ECE/TRANS/WP.29/2008/31
13 December 2007

Proposal for Supplement 10 to the Regulation No. 98
(Headlamps with gas-discharge light sources)

Submitted by the Working Party on Lighting and Light-Signalling (GRE) */

4. P+D (DCR) with the same light source

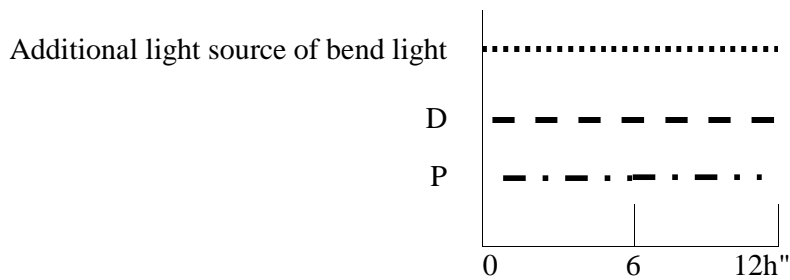
In the case of a passing beam and a driving beam provided by the same gas-discharge light source, the cycle will be:

15 minutes, passing beam lit
5 minutes, all driving beam contributors lit

Annex 4 – Appendix, amend to read:
